PUBLIC NOTICE OF INTENT TO
ISSUE PSD PERMIT MODIFICATIONSTATE OF FLORIDA
DEPARTMENT OF ENVIRONMENTAL
PROTECTION

Seminole Electric Cooperative, Inc.
Hardee Power Station Unit 3
Payne Creek Generating Station
Hardee County, Florida

HARDEE UNIT 3

**Second Sufficiency Comments/
Applicants Responses**

Figure FDEP.BWRM-8
 Plan View of Retainment Berm, Stormwater Pond, Entrance
 Roads, and Access Road Where Wetland Impacts Will Occur
 (Revised 10/06/94)

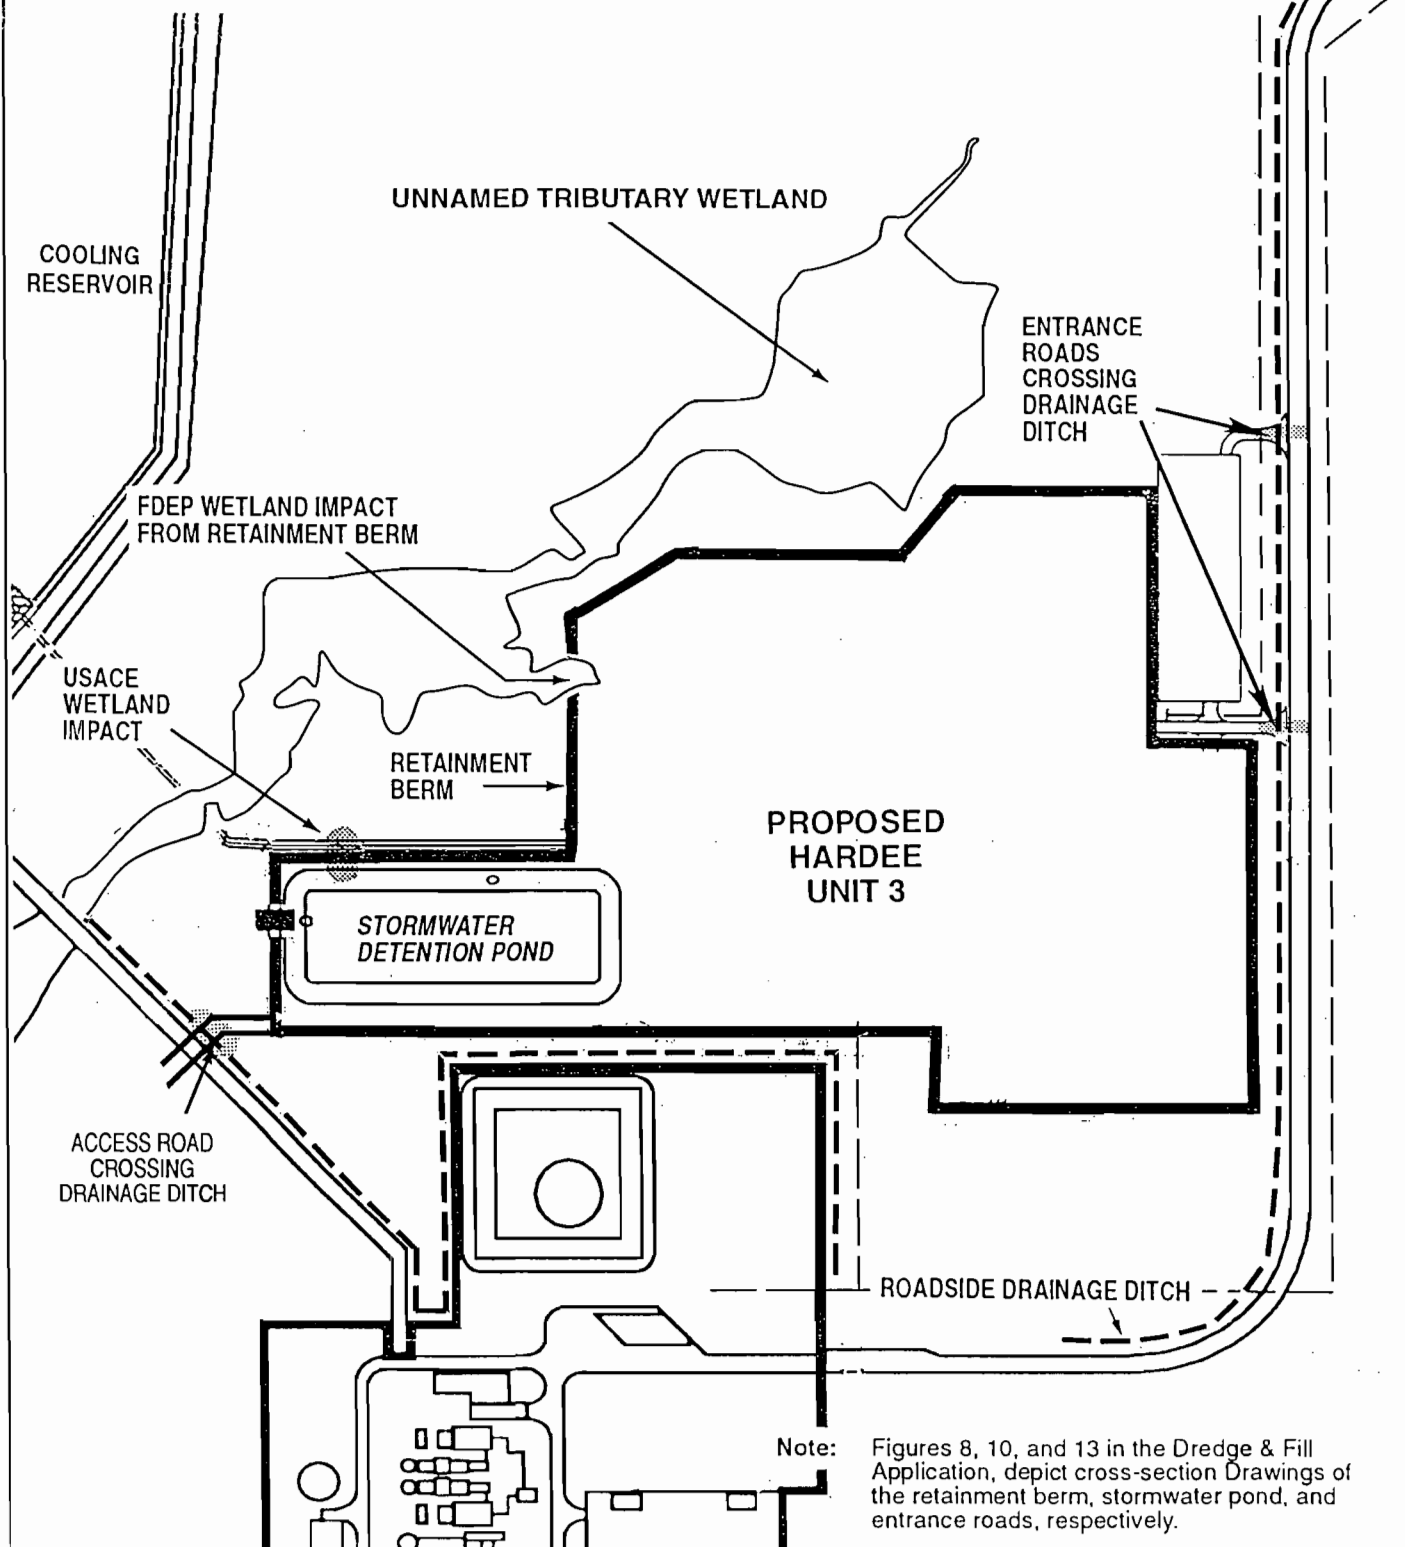
Comment: Figure 9 shows a road crossing a jurisdictional drainage ditch southwest of the detention basin. This ditch crossing is not shown on Figure FDEP.BWRM-8. Please revise the appropriate drawing to resolve this conflict and submit the revised drawing to the Bureau.

Figure 4
 Plan View of Mitigation Sites
 (Revised 10/12/94)

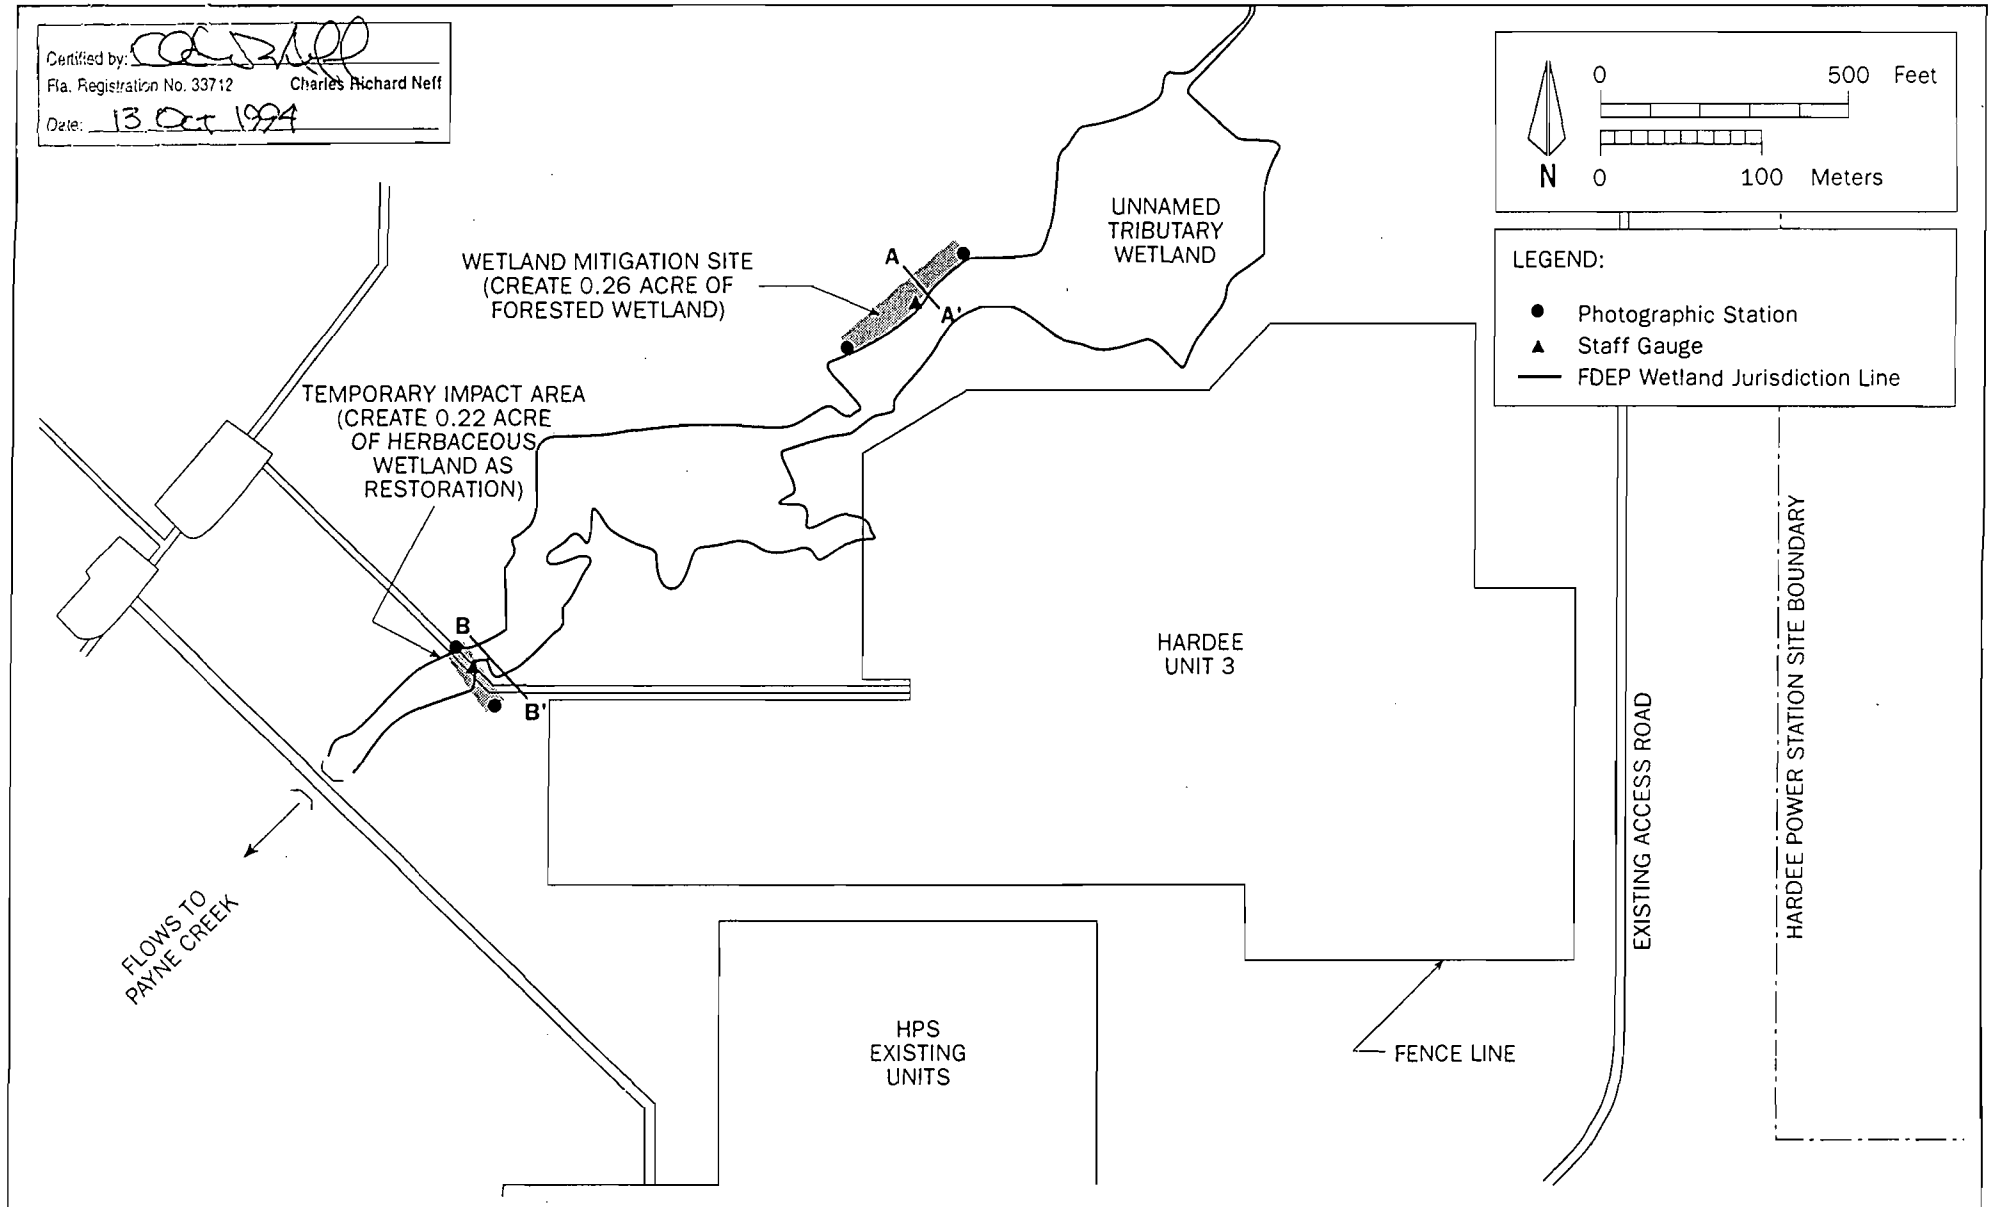
Comment: Please revised Figure 4 to label the wetland restoration area as a temporary impact area. The current labeling indicates that the pipeline crossing is a mitigation area rather than an area of temporary impact that will be restored.

Response: Figure 4 has been revised and is attached.
